Subject: Response to Public Comments on Potential Case Closure for Fuel Leak Case No. RO0000207 and Geotracker Global ID T0600102092, Mission Valley Rock and Asphalt, 7999 Athenour Way, Sunol, CA 94586

Hanson Aggregates (Hanson) received a letter from Alameda County Environmental Health (ACEH) dated February 1, 2012 that includes three technical comments that represent public inquiry to the pending potential case closure of the Mission Valley Rock and Asphalt site (the Hanson Site) in Sunol, California. ACEH requested Hanson provide written response to the three technical comments.

New Irvington Tunnel Location

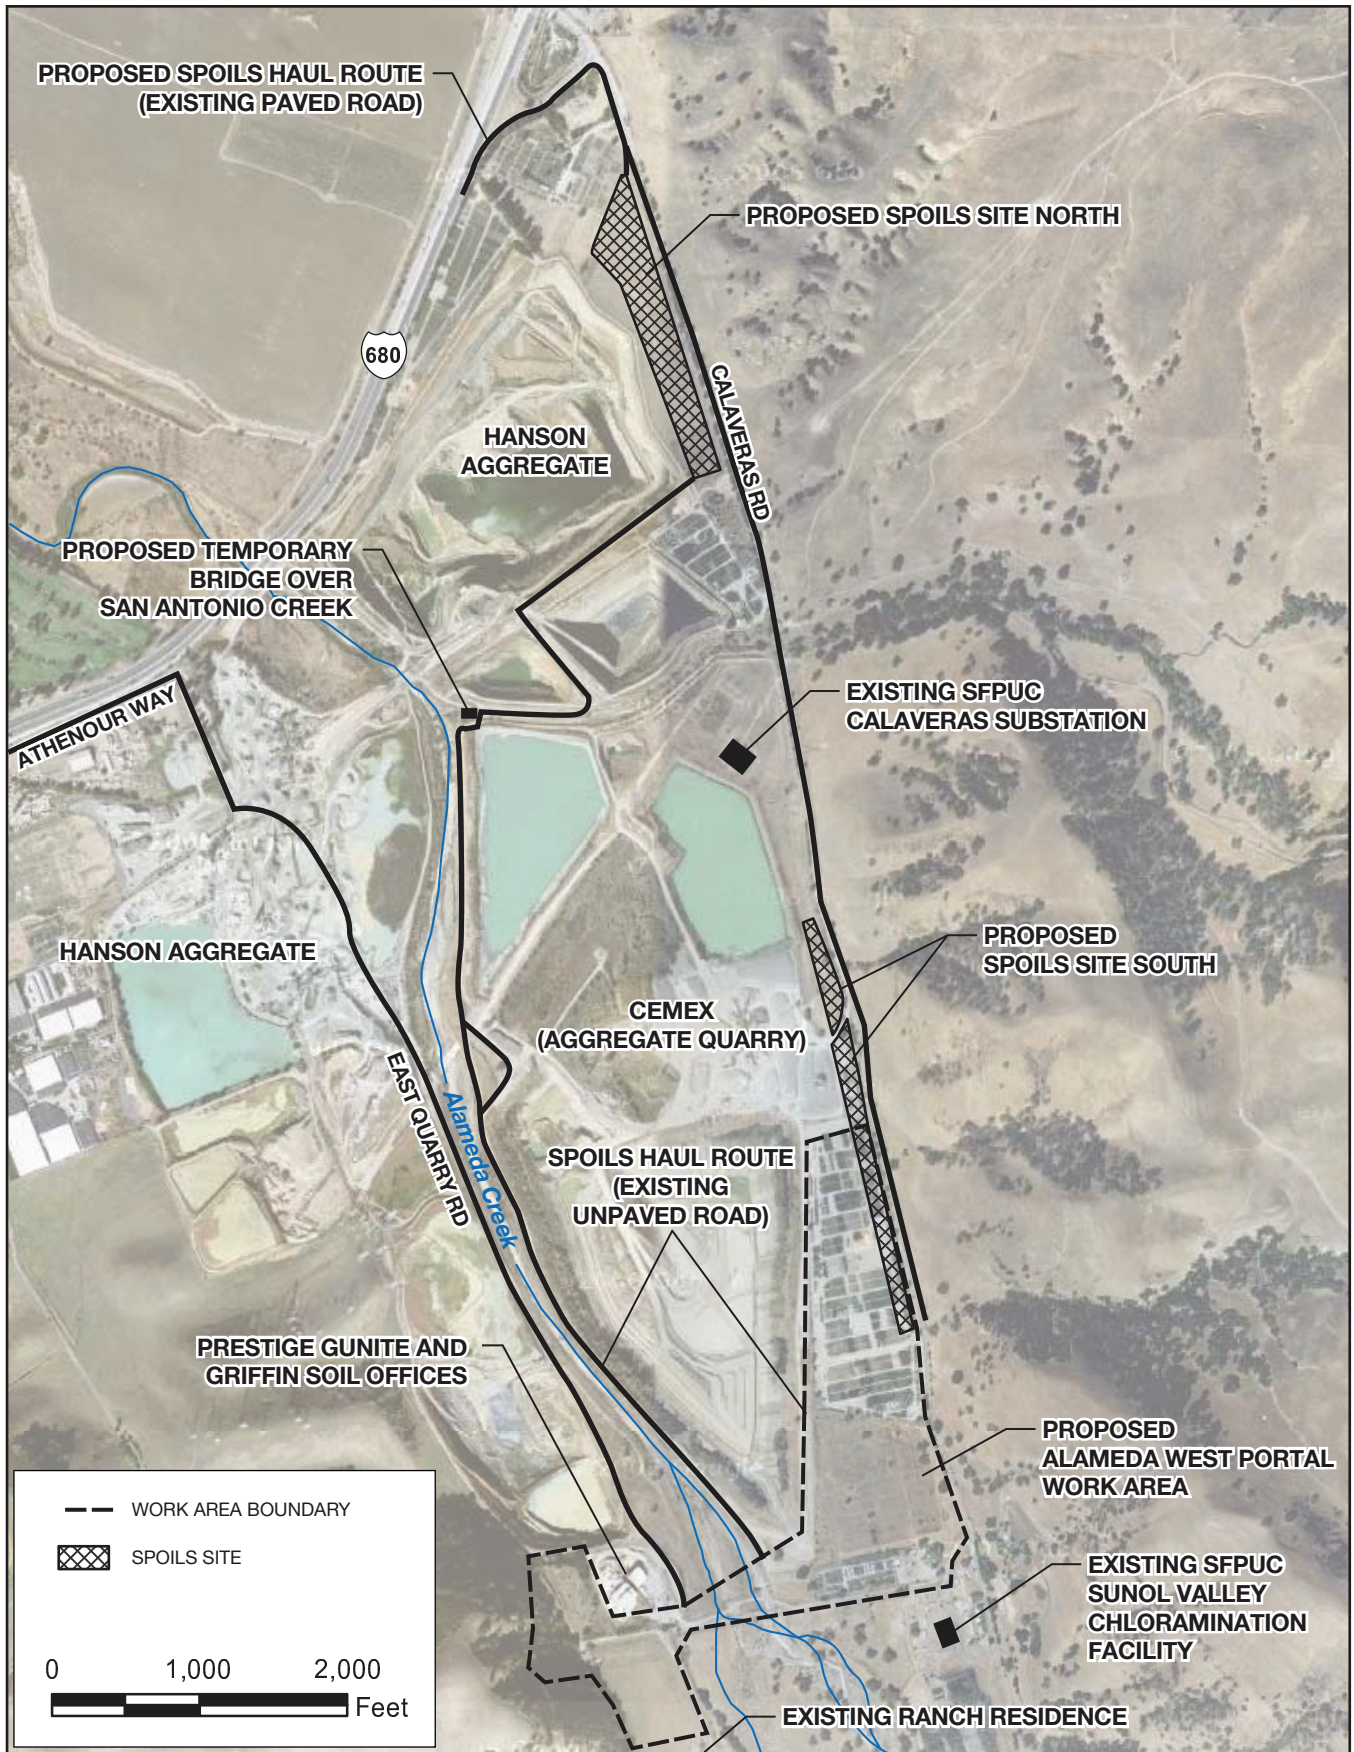
Please evaluate whether there could be an interaction between the contaminant plume from the fuel leak at the Hanson asphalt plant and the aquifer under Sheridan Road that SFPUC is currently draining with 23 wells.

The SFPUC Project involves the construction of a 3.5-mile-long, 8.5- to 10.5-foot-diameter tunnel between Sunol Valley in an unincorporated area of Alameda County and the City of Fremont. A map of the SFPUC Project location, including the trace of the tunnel, is presented as Figure 2-1 in the EIR (Attached). The part of the proposed tunnel that is located closest to the Hanson Site is approximately 6,000 feet south of the Hanson Site (greater than 1 mile).

<p align="center">NEW IRVINGTON TUNNEL PROJECT</p>	<p align="center">Alameda West Portal Work Area and Spoil Sites</p>	<p align="center">FIGURE 3-3</p>
---	---	--	---

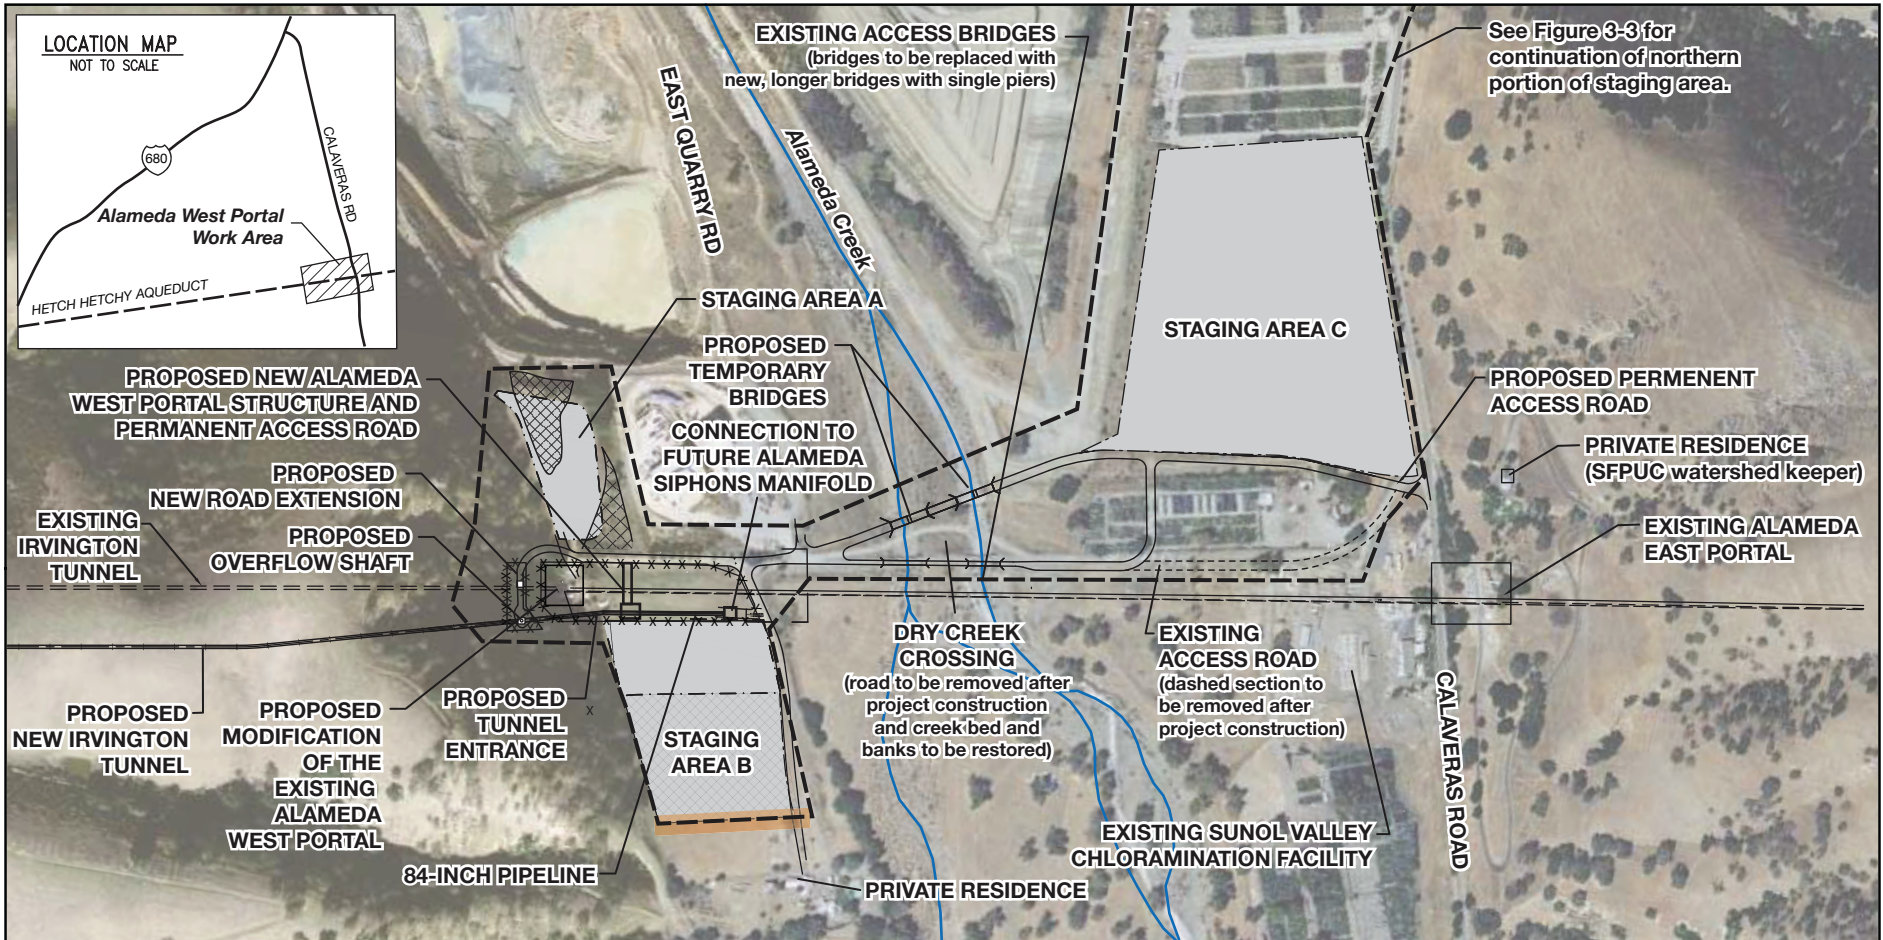
Please expand your evaluation from technical comment 1 to include discussion of possible impacts to the fuel leak plume caused by any other current or planned construction projects in the area of the asphalt plant.

Additional construction activities associated with the SFPUC Project are planned to take place near the Hanson Site. The activities are proposed to take place at a work area designated as the Alameda West Portal Work Area (see Figure 3-3 of the EIR, attached). This work area is characterized by undeveloped land, ranchland, quarry operations, landscaping nurseries, and SFPUC water conveyance system facilities located almost entirely east of Alameda Creek (the Hanson Site is located west of

Based on information above, and the location and characteristics of the Hanson Site, there are no impacts to the fuel leak plume at the Hanson Site caused by the activities in the area designated as the Alameda West Portal Work Area, associated with project construction.
